**SUSQUEHANNA STEAM ELECTRIC STATION  
PROPOSED AMENDMENT NO. 282 TO  
FACILITY OPERATING LICENSE NPF-14:  
PROPOSED CHANGE TO TECHNICAL SPECIFICATION 2.1.1.2  
MCPR SAFETY LIMIT  
AS-LEFT CORE LOADING PATTERN  
PLA-5982**

**Docket No. 50-387**

**As-Left Core Loading Pattern**

# SUSQUEHANNA UNIT 1 CYCLE 14 POST-MAINTENANCE OUTAGE REFERENCE CORE LOADING PATTERN

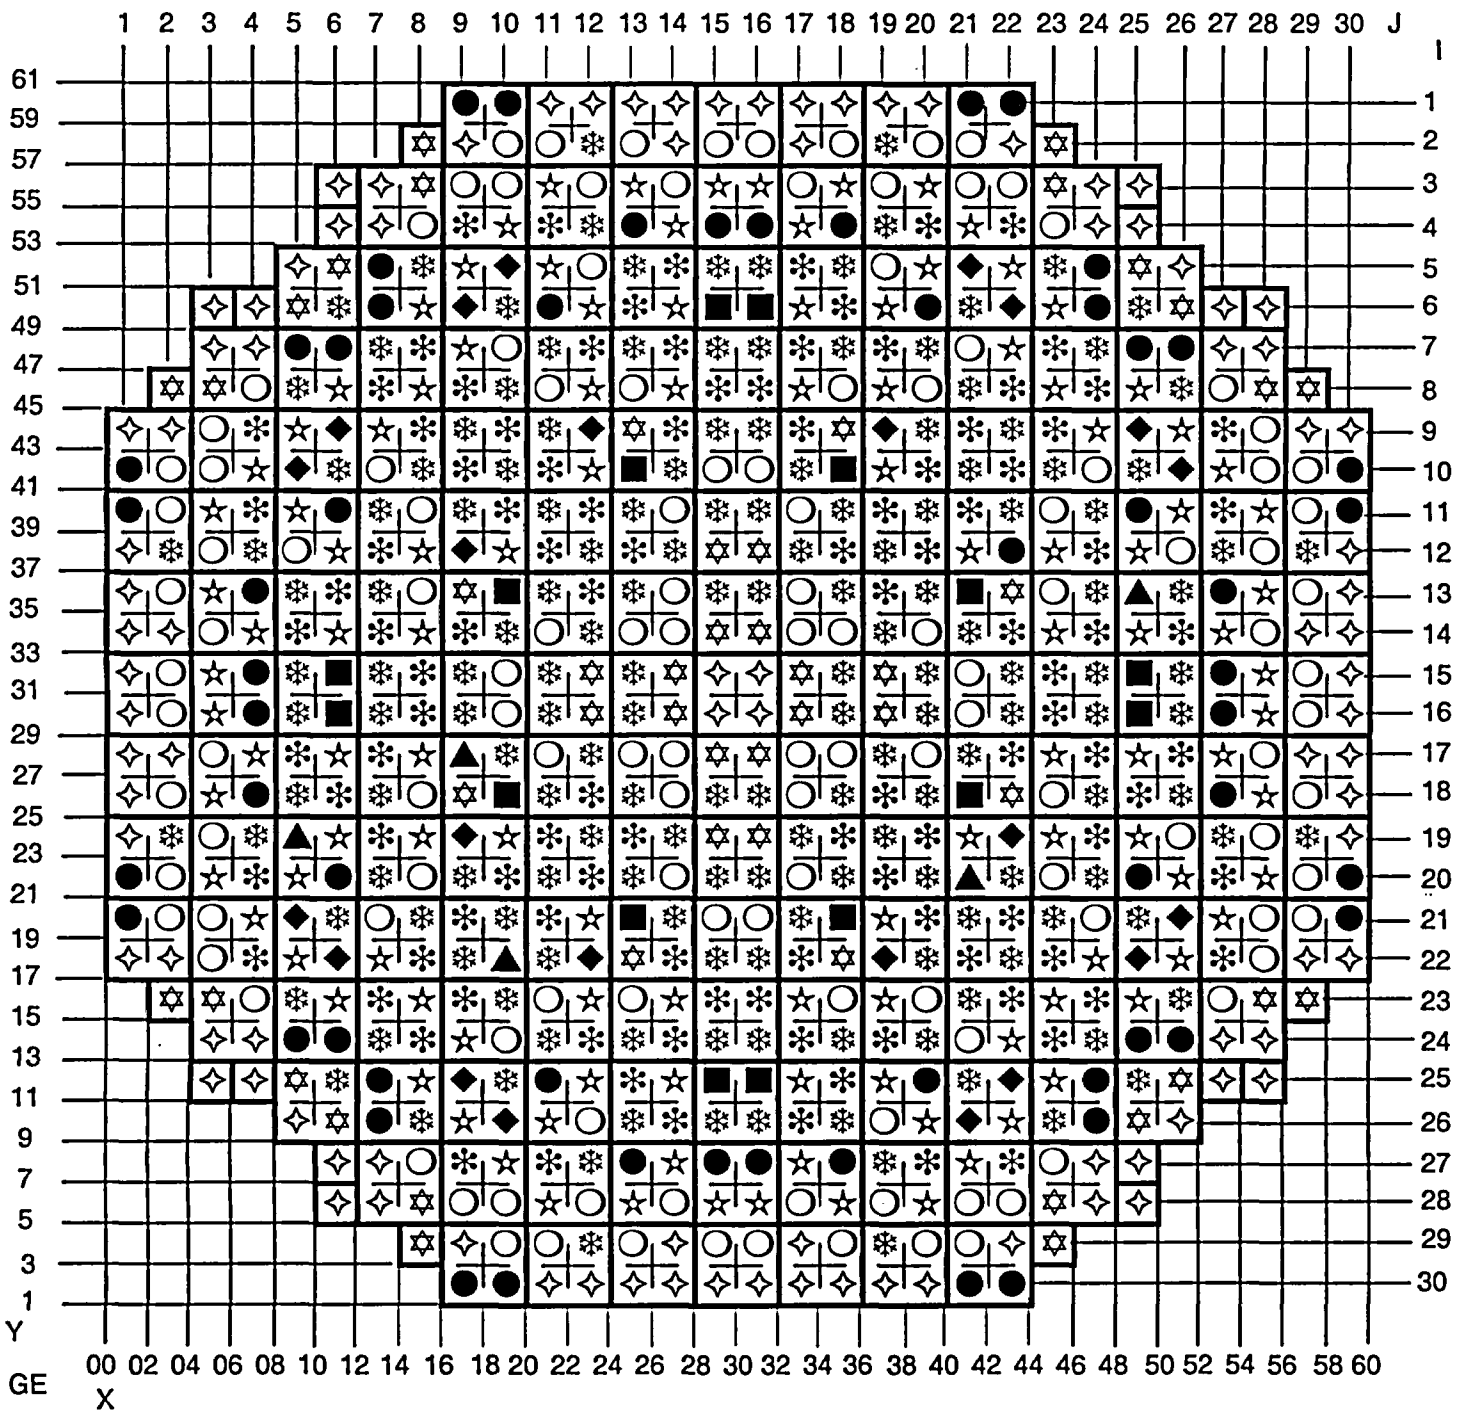
Channel bow measurements determined that 58 bundles required rechanneling. Rechanneling efforts were successful for 54 bundles; however, 4 bundles could not be rechanneled. These 4 bundles were operated in the U1 core for approximately 1¾ cycles. Because these bundles could not be rechanneled, they were subsequently discharged and replaced with 4 twice-burned bundles, whose bow was measured prior to insertion.

Post maintenance control rod stroking indicated that additional action was warranted for two control cells. As a result, an additional 2 bundles were discharged and replaced with previously characterized twice-burned fuel bundles from the spent fuel pool.

Since the reinserted twice-burned bundles are lower in reactivity than the bundles they replaced, there is no loss of shutdown margin. These bundles are designated as SQA-10 and SQA-11 on the attached as-left core-loading pattern.

As a result of fuel bundle rechanneling, shuffle activities, and control rod stroking, control cell friction in the core has been reduced. All control cells exhibiting friction prior to the shutdown and those susceptible to future friction have been addressed through channel replacements, fuel shuffling, or by reinserting previously discharged fuel. Visual inspection and bundle measurement results were consistent with pre-outage expectations and the MCPR Safety Limit in Reference 1 is valid for the core-loading pattern shown in the attachment.
